UNITED STATES
DEPARTMENT OF THE INTERIOR
BUREAU OF LAND MANAGEMENTNM OIL CONSERVATION
ARTESIA DISTRICTFORM APPROVED
OMB NO. 1004-0135
Expires: July 31, 2010SUNDRY NOTICES AND REPORTS ON WELLS
Do not use this form for proposals to drill or to re-enter an
abandoned well. Use form 3160-3 (APD) for such proposals.

OXY USA Inc. respectfully requests approval for the following changes to the approved APD:

API Number 30-015-43281	Pool Code 916473	Pool Name Pierce Crossing Bone Springs, E.
Property Code 315018	Property Name CEDAR CANYON "23" FEDERAL	Well Number 4H
OGRID No. 116696	Operator Name OXY USA INC.	Elevation 2942.4'

**PECOS DISTRICT
CONDITIONS OF APPROVAL**

OXY USA INC. CEDAR CANYON "23" FEDERAL #4H SITE PLAN

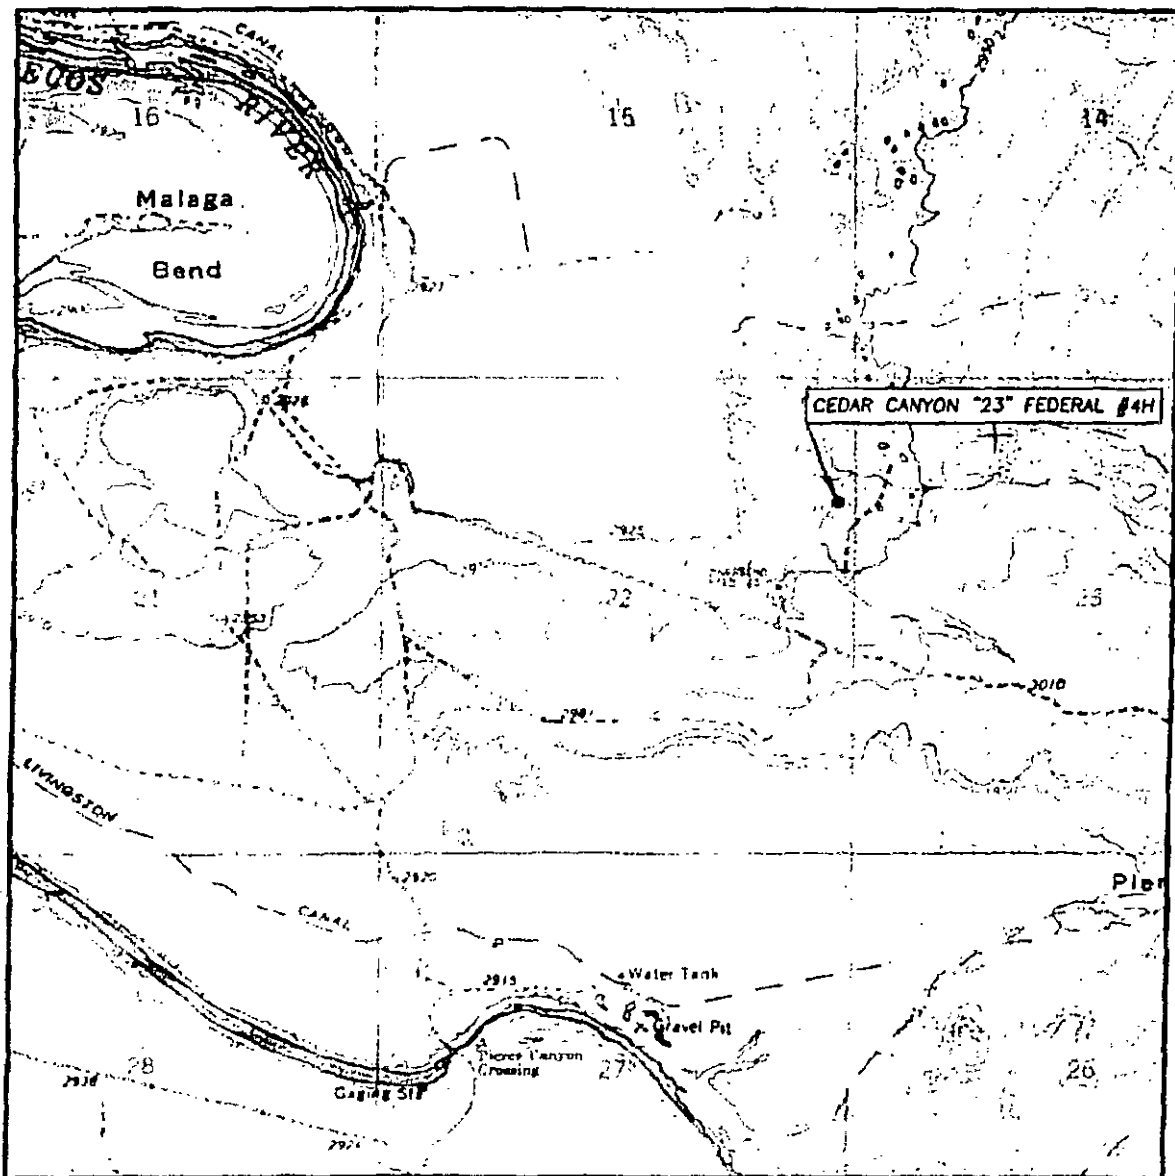
1. Move Surface Location to a multi-well pad to accommodate skidding the rig.
2. Amend horizontal lateral - NSL to be filed
3. Amend casing/cementing/mud programs
4. Propose to run the wellhead through the rotary prior to cementing surface casing.

New - SL 1352 FNL 195 FEL SENE Sec 22 - BHL 1415 FNL 2460 FWL SENW Sec 24
Old - SL 1415 FNL 155 FEL SENE Sec 22 - BHL 1700 FNL 2460 FWL SENW Sec 24
